# Access Compliance Report

## Public Rights-of-Way

Intersection ID: 48437	Main Street: LATHERTON_LN	Cross Street: CULLEN_CT	Location: NE
ADA ID: 4D3158AB6200	Ramp Type: PerpDiag	Initial Pass/Fail: Fail	Overall Compliance: No
Severity Score: 8.75			
Codes/Mitigation Info/Possible Solution		Field Measurements/Component Compliance

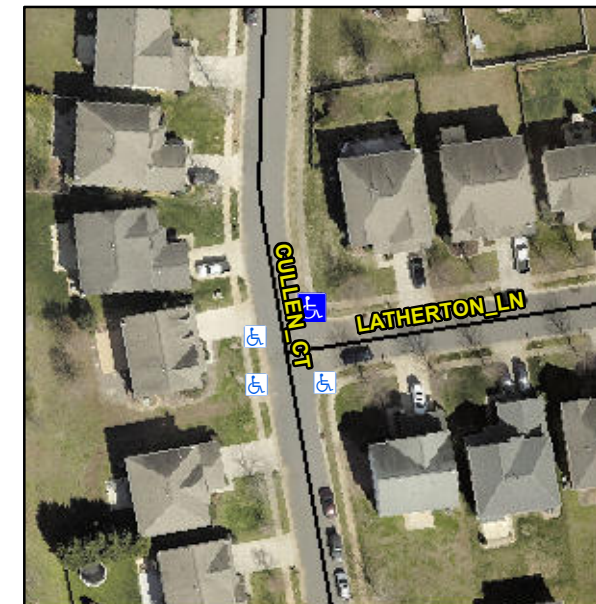
Compliance	Description	Data	Compliance	Description	Data
N/A	Ramp Length (in)	46.0	Yes	Ramp Slope (%)	5.4
No	Ramp Width (in)	45.0	Yes	Ramp XSlope (%)	1.2
N/A	Flare Type LT	N/A	N/A	Flare Type RT	N/A
N/A	Flare Slope LT (%)	N/A	N/A	Flare Slope RT (%)	N/A
N/A	Flare Traversable LT?	N/A	N/A	Flare Traversable RT?	N/A
N/A	Landing Length (in)	N/A	N/A	DWS Provided?	N/A
N/A	Landing Width (in)	N/A	N/A	DWS Contrast?	N/A
N/A	Landing Slope (%)	N/A	N/A	DWS Length (in)	N/A
N/A	Landing X Slope (%)	N/A	N/A	DWS Full Width?	N/A
N/A	Landing Curb? (Y/N)	N/A	N/A	DWS Offset (in)	N/A
N/A	Shared Landing?	N/A			
N/A	Gutter Ponding?	N/A	N/A	Gutter Slope (%)	N/A
N/A	Gutter Lip Ht (in)	N/A	N/A	Gutter X Slope (%)	N/A
N/A	Painted X Walk1?	No	N/A	Painted X Walk2?	No
	X Walk 1 Direction	To W		X Walk 2 Direction	To S
N/A	X Walk 1 Width (in)	N/A	N/A	X Walk 2 Width (in)	N/A
	X Walk 1 Slope (%)	1.7		X Walk 2 Slope (%)	2.5
	X Walk 1 X Slope (%)	0.6		X Walk 2 X Slope (%)	1.9

N/A	Ramp inside XWalk1?	N/A	N/A	Ramp inside XWalk2?	N/A
	Road Slope (%)	1.4	N/A	Clear Space?	N/A
	Road X Slope (%)	1.7	N/A	Clear Space to XWalk (in)	N/A
N/A	Any Obstructions?	N/A	N/A	Storm Grate/Utility Hazard?	N/A
	Obstruction Type			Storm Grate/Utility Type	
		N/A			N/A
		Yes		Surface Condition? (G/P)	Good

**Remove & Replace Curb Ramp With Two New Directional Ramps or Equivalent.**

**R304.5.1**
